PROJECT: Highgate Senior Living

SUBMITTAL: 1st Submittal

CITY OF LAS VEGAS		DATE:
INTER-OFFICE MEMORANDUM		November 18, 2016
TO: Land Development Services Department of Building & Safety		FROM: Albert Sung, P.E.  Flood Control Project Engineer Department of Public Works
SUBJECT:	Drainage Study for:	COPIES TO:
	Highgate Senior Living	Collins Engineers, Inc.
Cross Streets:	SEQ of Lake Mead Boulevard and Rock Springs	Buron, Inc.
File Number:	F:\Depot\DSMemos\DS4838A.doc	Bart Anderson, P.E., DevCo
Parcel Number:	138-22-702-002	
Zoning Action:	SDR-65235; SUP-60376; ZON-60375	
FEMA Flood Zone	YES NO X	
Proposed Storm Drain	YES X NO

Technical Drainage Study for Highgate Senior Living

Worksheet for FM2-WITH APPROVED FLOW -Q100=67 CFS

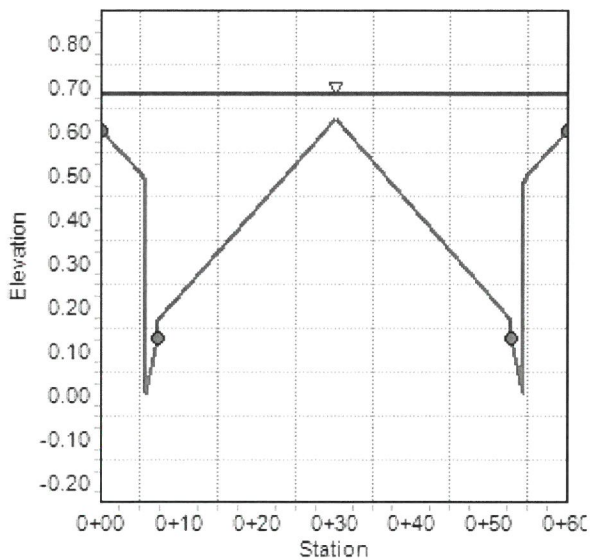
3. Revise finish floor elevations to be minimum of 8-inch above the highpoint of the onsite swale adjacent to the proposed buildings.
4. Check the velocity head for the "REF1" of 100-year flow of 67-cfs heading toward the proposed site to verify that no additional flow enters the site.

Nyloplast 12" Drop In Grate Inlet Capacity Chart

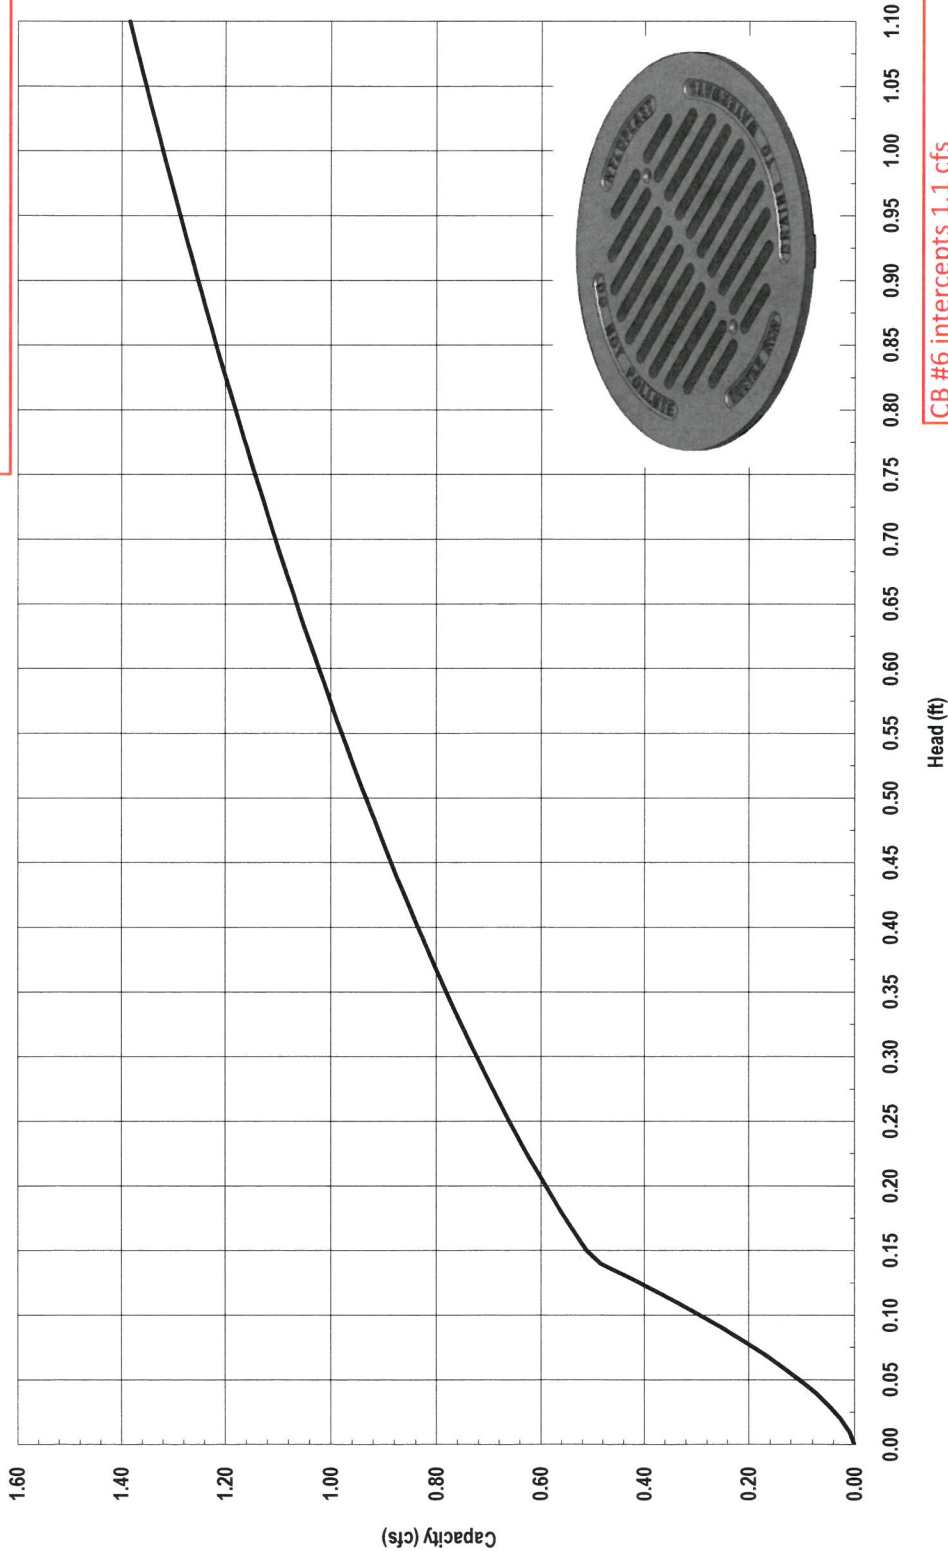
6. Is the proposed 12-inch NYLOPLAST drop inlet calculation includes 50-percent clogging factor?

GRADING PLAN

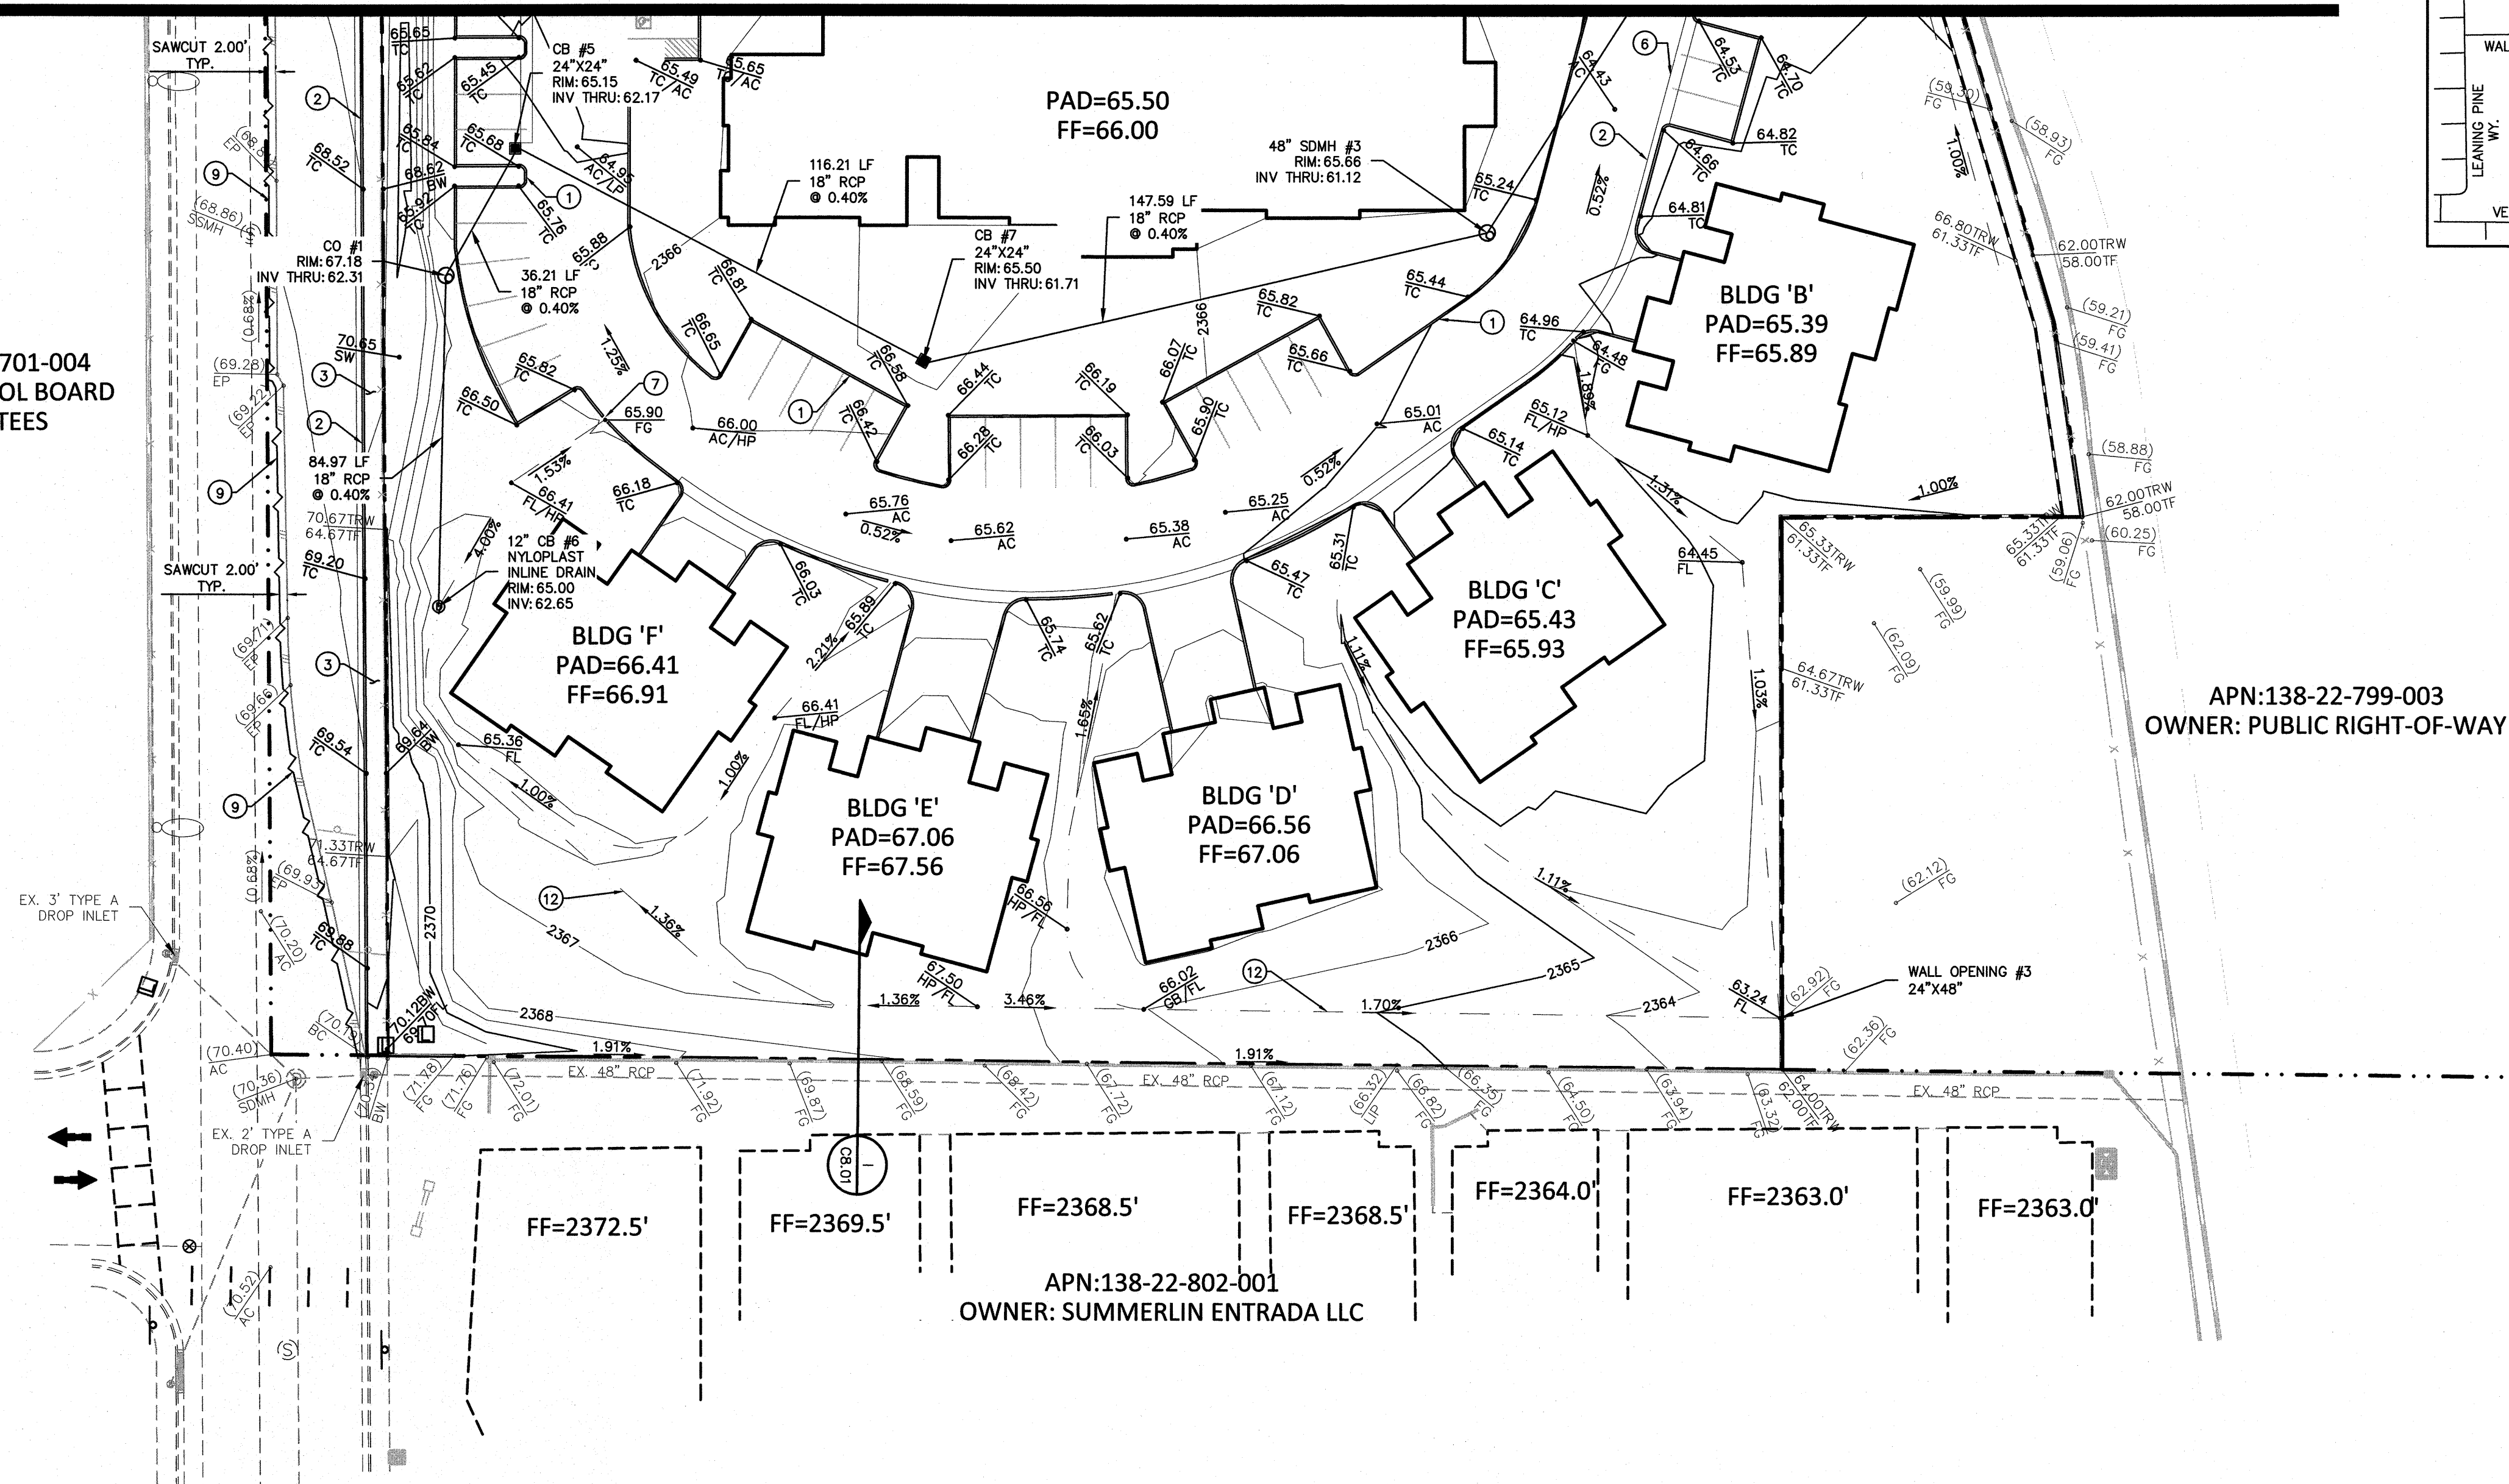
7. Provide an overflow opening for the proposed drop inlets along the east and northern boundary walls.
8. Label Document Number or Book and Page Number for all existing easements on the grading plan.
9. Provide a detail for the proposed drop inlet and manhole on the plan.
10. Provide a detail on how the proposed 18-inch RCP ties into the proposed wall openings.
11. Label CLV drawing number for the existing storm drain in Rock Springs.
12. Label right-of-way width, street name, and drainage study compliance note in the grading plan.
